E-3 AWACS
CORROSION PREVENTION ADVISORY BOARD
(CPAB)

12 JULY 1990
TINKER AFB, OK

E-3 CORROSION PREVENTION ADVISORY BOARD MINUTES
12 JULY 1990

SEE NOTE ON PARTS LIST PAGES
FIGURE 17. DUCT INSTL, WING LEADING EDGE CABIN AIR (SHEET 1)

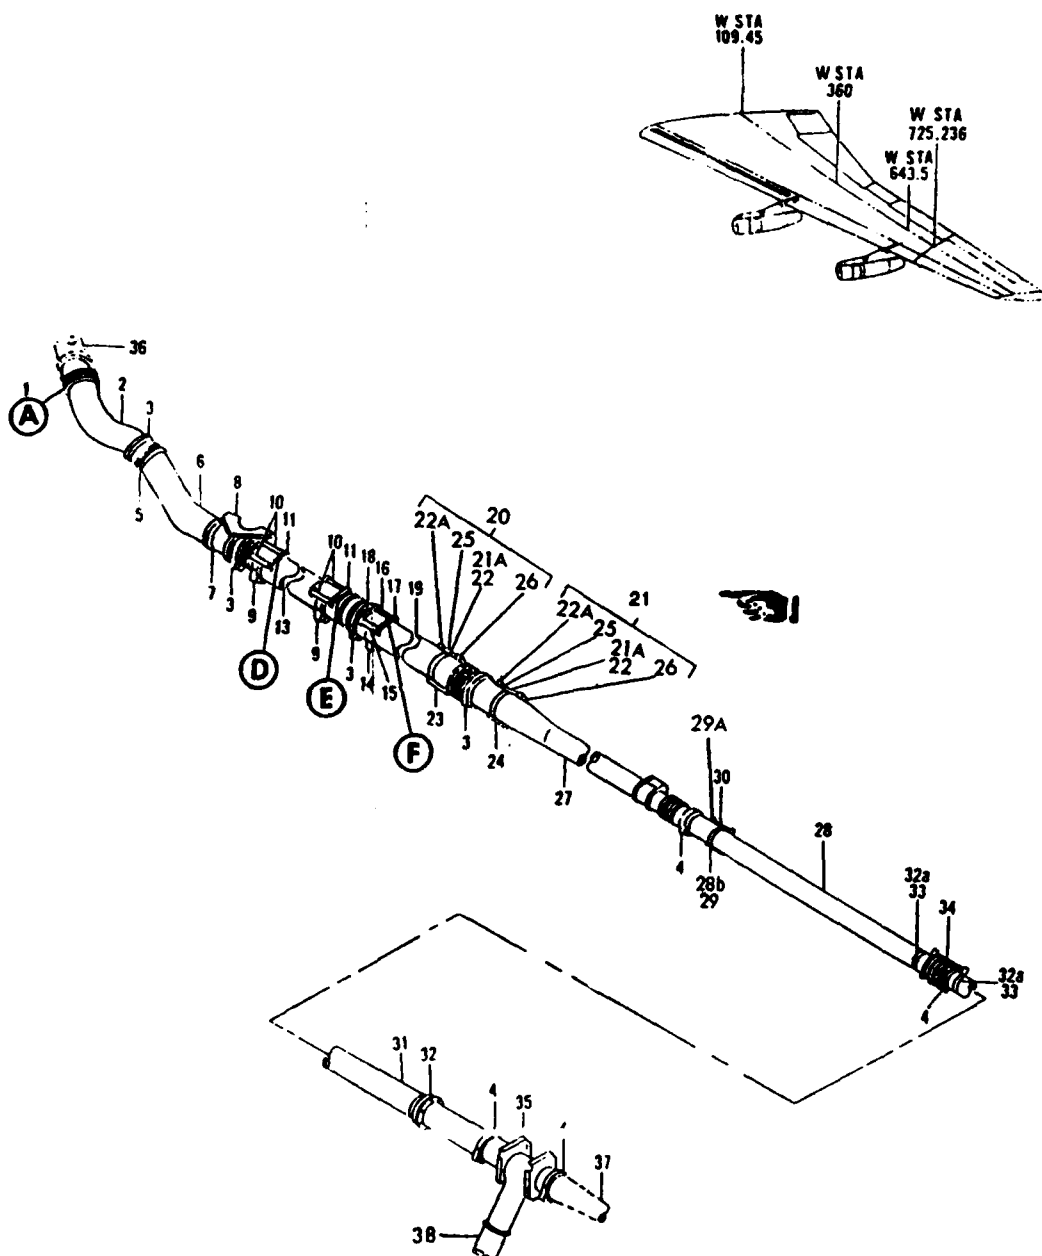
E-3		CORROSION PREVENTION ADVISORY BOARD		ACTION ITEM #: 89-05	
O R I G I N A T O R	SUBJECT: Bleed Air Ducts		BACKGROUND DATA:		
			PART NUMBER: See parts list in Recommended Action below. NSN: DRAWING(S):		
	NAME: Barry Schnauber ORGANIZATION: 552EMS/MAEBC TELEPHONE: (405) 734-3826 DATE SUBMITTED: 23 MAY 1989		TO(S): 1E-3A-4-21-1 FIGURE: 21-01-017 INDEX: WORK UNIT CODE:		
	PROBLEM: Corrosion has been found on the wing leading edge bleed air ducts. No rework procedures exist in the Tech Orders.				
RECOMMENDED ACTION: Investigate corrosion on bleed air ducts and determine rework procedures for inclusion into Tech Order.					
(USE CONTINUATION SHEET IF NECESSARY)					
C P A B A C T I O N	STATUS: May 1989: MMKRA will investigate the problem and coordinate with Boeing to determine implications and solutions.				
	Nov 1989: Boeing response: 707 history indicates no reports of corrosion on the ducts. Material used is AISI 321 or 347 CRES tubing per BMS 7-41, condition annealed. In non-severe environments such as those common to the E-3 this stainless steel is inert. Some light rust is to be expected but does not indicate that a corrosion problems exists.

Statement of work for L.E. skin will require removal of bleed air ducts. MMKRA will look again at bleed air ducts and replace it as necessary. The diameter for the out-board ducts are .016" and for the in-board ducts are .050". Maximum allowable pitting for out-board and in-board are .002" and .003" respectively. If replacement ducts are not available, MMKRA will generate repair procedures.

NAEWF E-3 Component reported no corrosion found on ducts.

SEE NOTE ON PARTS LIST PAGES
FIGURE 67 SPEAKER INSTL. NOSE GEAR

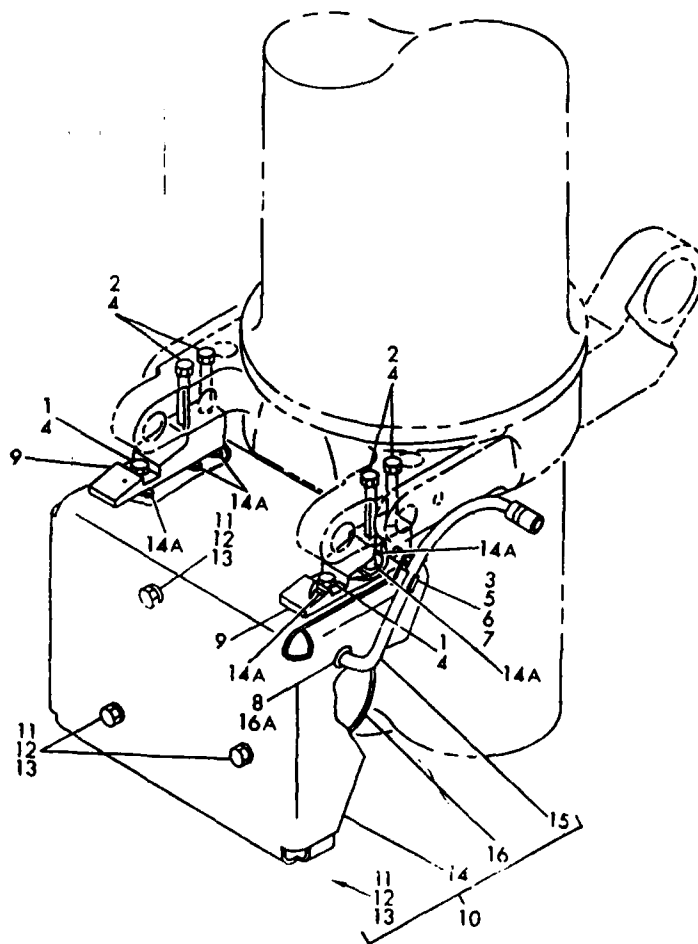
E-3	CORROSION PREVENTION ADVISORY BOARD		ACTION ITEM #: 89-06
O R I G I N A L T O R	SUBJECT: Spacer - Speaker Support, Nose Gear	BACKGROUND DATA: PART NUMBER: 204-56399 NSN: N/A DRAWING(S): 204-56399, 204-56353	
	NAME: TSgt. Charles Faircloth ORGANIZATION: 961 AWACS/MACM TELEPHONE: DATE SUBMITTED: 23 May 1989	TO(S): 1E-3A-4-23 FIGURE: 04-67 INDEX: 09 WORK UNIT CODE:	
	PROBLEM: Bracket is corroding excessively in an area where there is no apparent cause for corrosion. Parts can not be ordered and are being locally manufactured at Kadena AB.		
	RECOMMENDED ACTION: Determine cause of corrosion and a method for eliminating/reducing corrosion. Ensure part numbers are stock-listed and provide the necessary tech data for finish requirements. (USE CONTINUATION SHEET IF NECESSARY)		
C P A B A C T I O N	STATUS: May 1989: MMKRA will identify proper finishes to help protect these parts and attempt to determine the cause of corrosion. July 1989: Parts are corroding due to finish degradation. Part is for protection of the nose gear speaker bracket assembly from the tow bar hookup impact/chafing. Due to constant impact on the spacer, it is impractical to require frequent refinishing for corrosion protection. Other protective alternatives are being pursued. Nov 1989: MMKRA is investigating whether these parts can be stocklisted. Otherwise, parts can be locally manufactured if necessary. An ECO will be submitted against the drawing requiring an additional teflon coating. Once done, T.O. 1E-3A-23 will be updated to show the additional part requiring a teflon coating. (continued)

An ECO has been submitted for a teflon coating. No Tech Order change will be made to T.O. 1E-3A-23, Figure 13-16. When part is manufactured locally or bought on a new contract after stocklisting, requirement to have teflon coating will exist in drawing via ECO.

OC-ALC/MMKRTA has already requested stocklisting for the parts. No further action to be taken on this Action Item.

SEE NOTE ON PARTS LIST PAGES
FIGURE 13 ANTENNA INSTL, VHF/UHF STATION 600L, 844 AND 930 BLAD

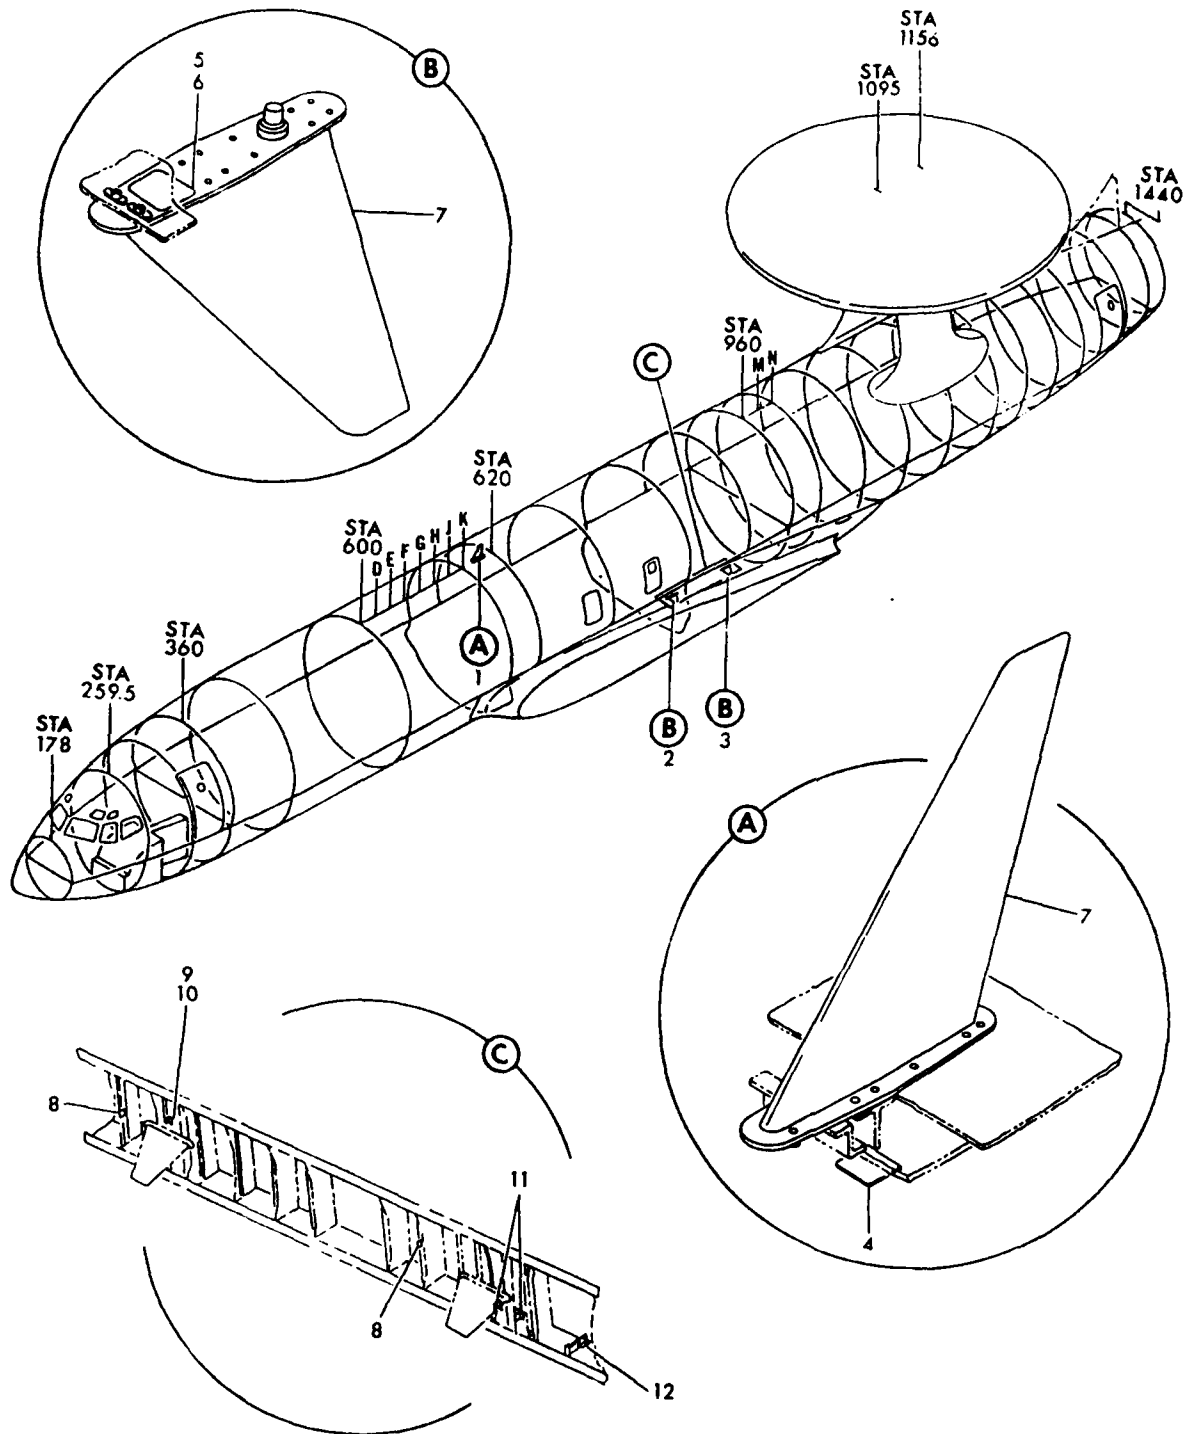
E-3		CORROSION PREVENTION ADVISORY BOARD		ACTION ITEM #: 89-07	
O R I G I N A L T O R	SUBJECT: VHF Antenna (#1 & 2) Corrosion		BACKGROUND DATA: PART NUMBER: 204-14994 NSN: DRAWING(S): 204-14994		
	NAME: TSgt. Charles Faircloth ORGANIZATION: 961 AWACS/MACM TELEPHONE: DATE SUBMITTED: 23 May 1989		TO(S): 1E-3A-4-23-01 FIGURE: 13 INDEX: 7 WORK UNIT CODE:		
	PROBLEM: The #1 and #2 VHF Antennas located on the keel beam between the main landing gear doors are corroding. Corrosion is more severe at the antenna/fuselage interface.				
	RECOMMENDED ACTION: (USE CONTINUATION SHEET IF NECESSARY)				
C P A B A C T I O N	STATUS: May 1989: OC-ALC Depot Maintenance also identified corrosion on these antennas. Rework procedures are being developed and MMKRA will determine what action is necessary to prevent future corrosion on the antennas and on the fuselage skin.				
	Nov 1989: SOW developed to repair antennas. Corrosion found on LE and mating surfaces between fuselage and antenna base. Rework requires refinishing, with conductive alodine. MMKRA is investigating the use of conductive sealant as a faying surface seal during rework.

OC-ALC/MMKRTB has tentatively approved painting the aluminum leading edges of the antennas and applying LE erosion tape. Once formally approved by MMKRTB in writing, a TCTO will be generated to accomplish painting/tape application, and the Tech Orders will be changed to show the new requirement.

MMKRA is working on statement of work for MMKRTA to generate TCTO. 552 AWACW requested form 252 be issued if SOW is not necessary. MMKRA took action to change T.O. rather than issue TCTO.

Figure 4-9. First Body Section Nose Gear Wheel Well Corrosion Inspection Guide (Sheet 1 of 2)

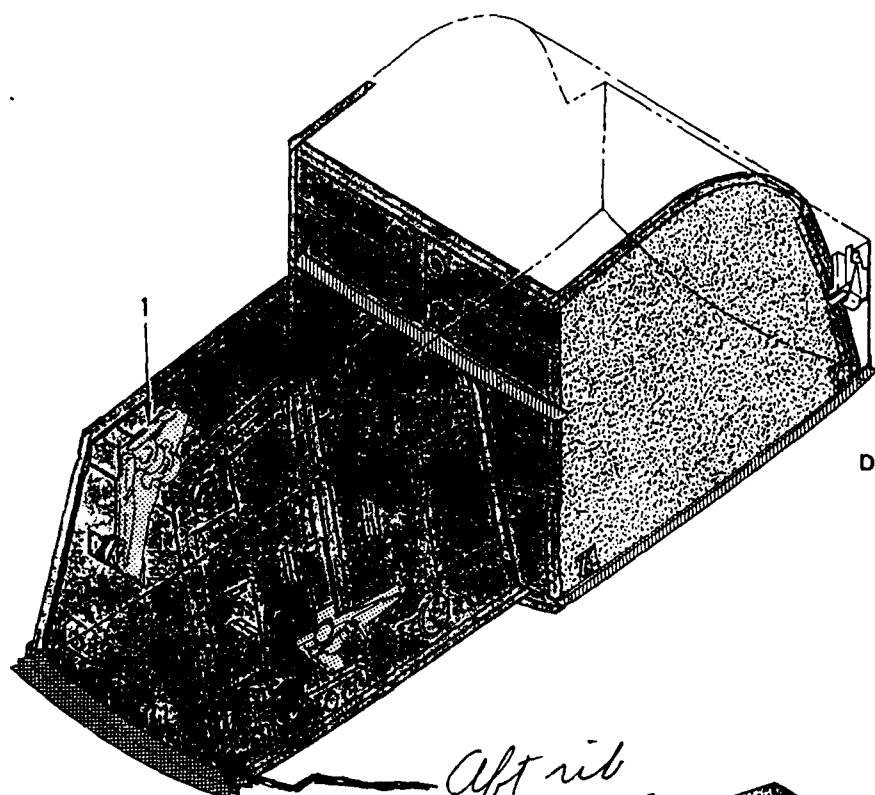
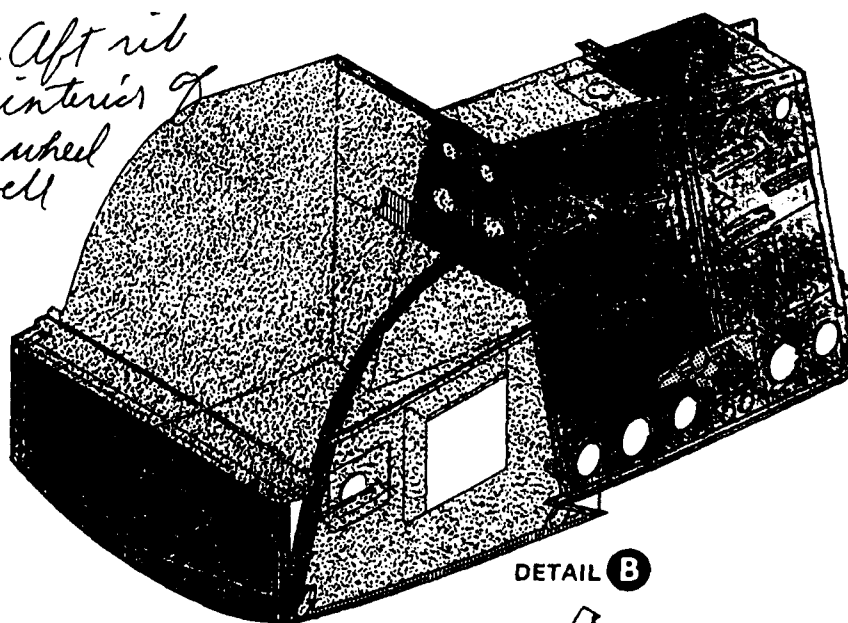
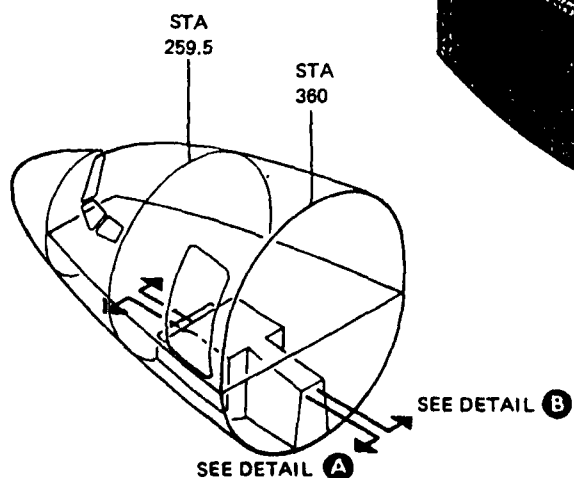
NAEWF E-3A Comp. reported that A/C 0442 through 0453 has no drain hole but sealant. A/C 0454 through 0459 has drain hole but no sealant. MMKRA/552 AWACW will take action to inspect USAF aircraft.

Figure 2-27. Wing Inboard Flap Structure Identification and Repair Index (Sheet 1 of 3)

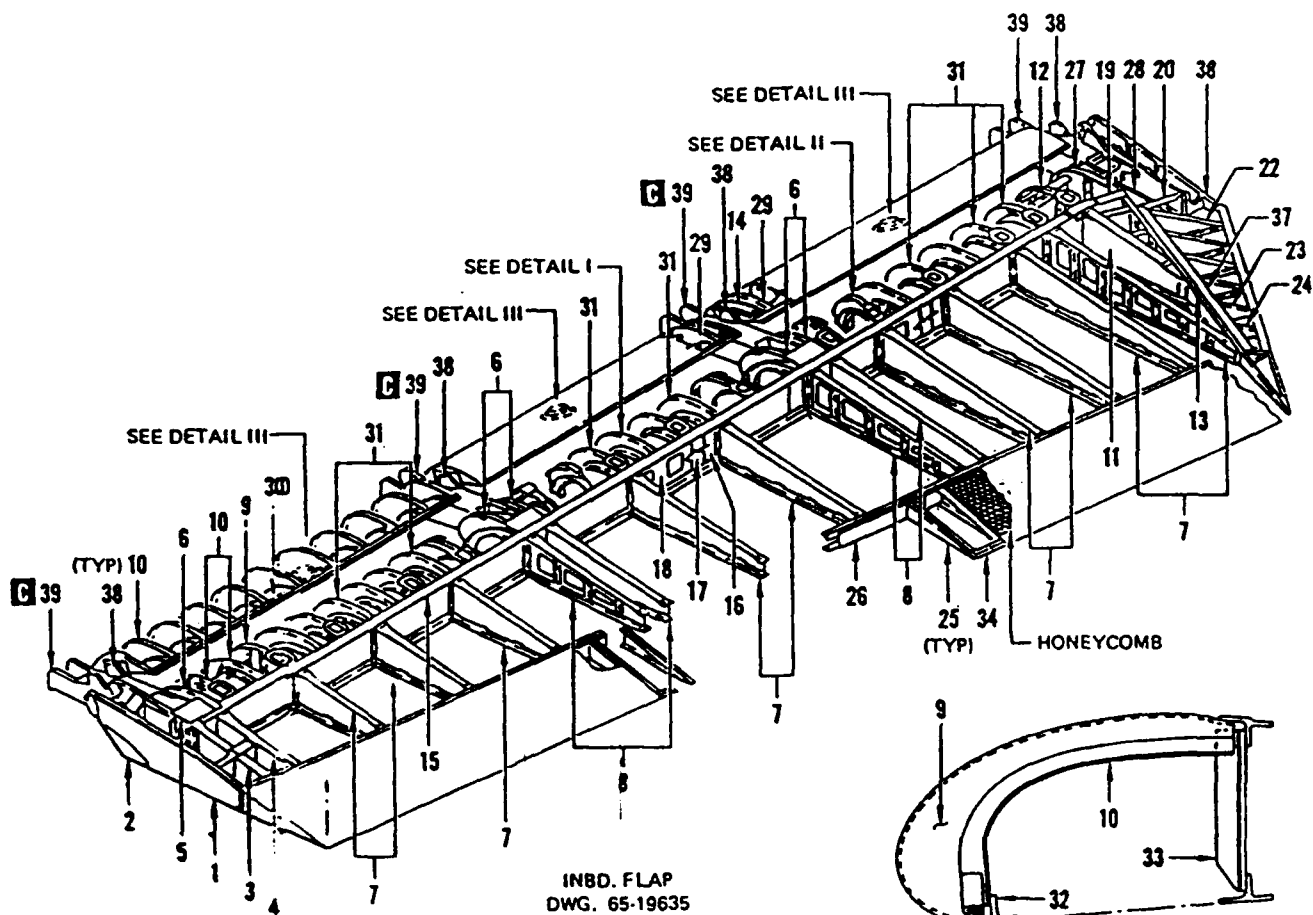
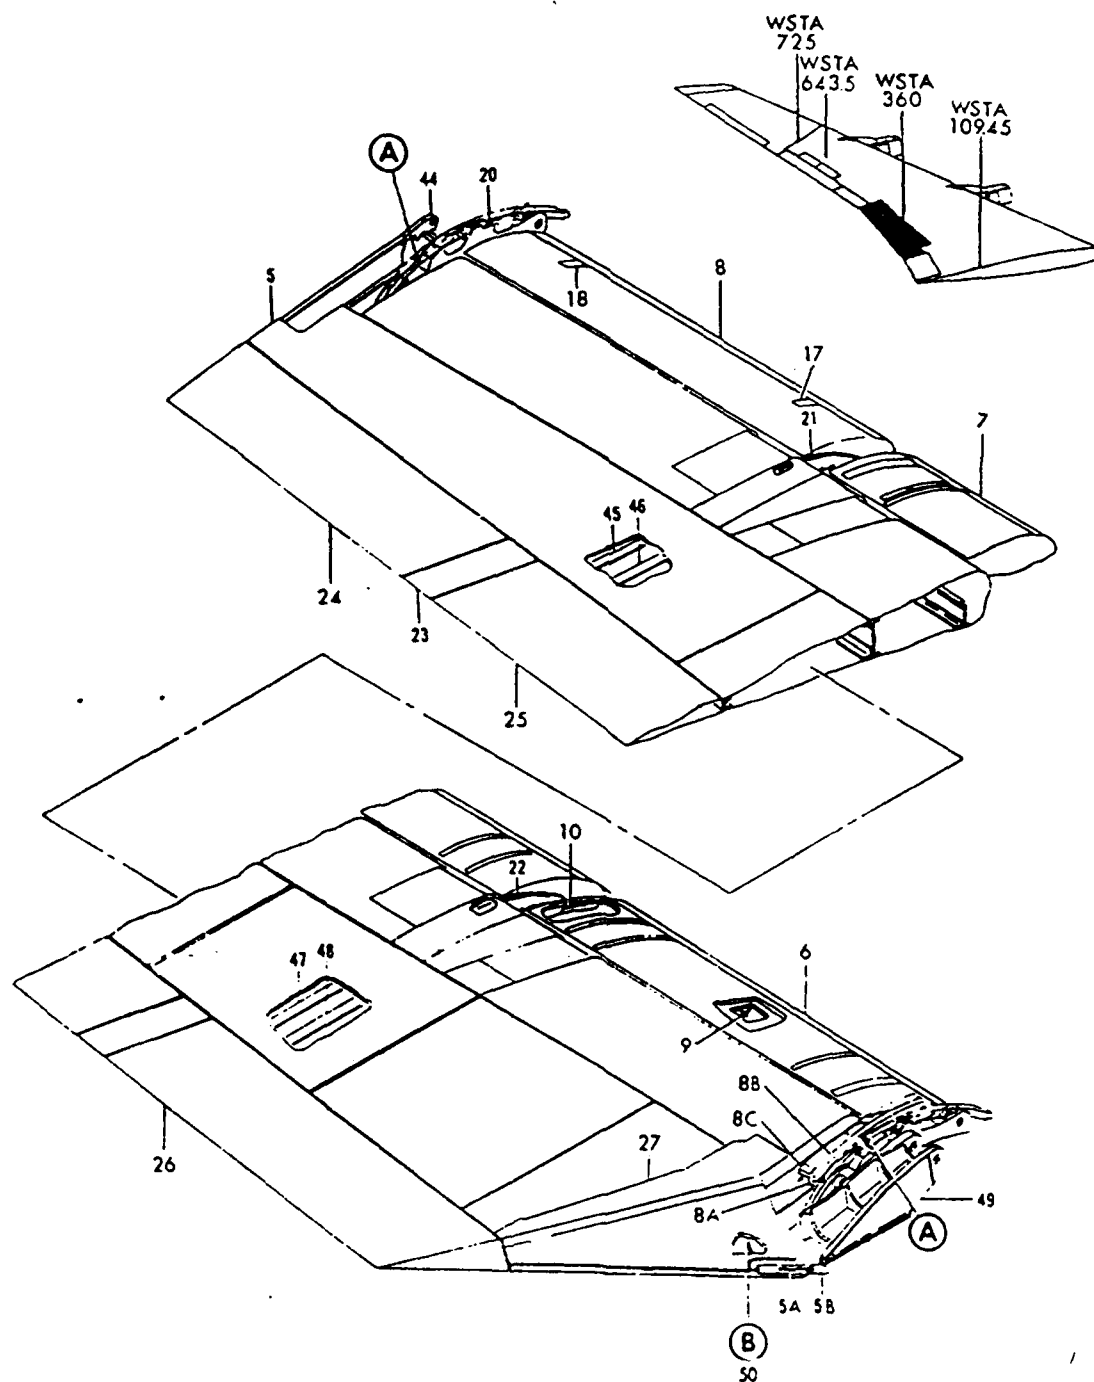
E-3	CORROSION PREVENTION ADVISORY BOARD		ACTION ITEM #: 89-11
O R I G I N A L T O R	SUBJECT: Inboard Trailing Edge Flap	BACKGROUND DATA: PART NUMBER: 65-18441-61/-62 NSN: DRAWING(S):	
	NAME: Hfw Franz-Josef Deckers ORGANIZATION: NAEWF E-3 Comp. TELEPHONE: 01-49-2451-63-6215 DATE SUBMITTED: 16 NOV 1989	TO(S): 1E-3A-4-27-1 FIGURE: 27-06-12 INDEX: 23 WORK UNIT CODE:	
	PROBLEM: Water is collecting in the inboard flap cavity. After removal of cover assy, 65-18441-33, excessive corrosion was found on the rivet nuts on bolt heads, as well as light corrosion on the flap structure. A/C 79-0454 and 79-0449 were inspected and the same condition was discovered.		
	RECOMMENDED ACTION: Install drain holes in the inboard edge of the lower cover assembly (USE CONTINUATION SHEET IF NECESSARY)		
C P A B A C T I O N	STATUS: 16 Nov 1989: OC-ALC/MMKRA will investigate, prepare ECO, and coordinate TCTO with OC-ALC/MMKRTA to install drain hole(s) as necessary to correct problem. 12 March 1990: No action has been taken yet by OC-ALC/MMKRA. July 1990: OC-ALC/MMKRTA is generating a TCTO to inspect and install drain hole(s) as necessary. Kitproof/publication scheduled for late Sept 90.
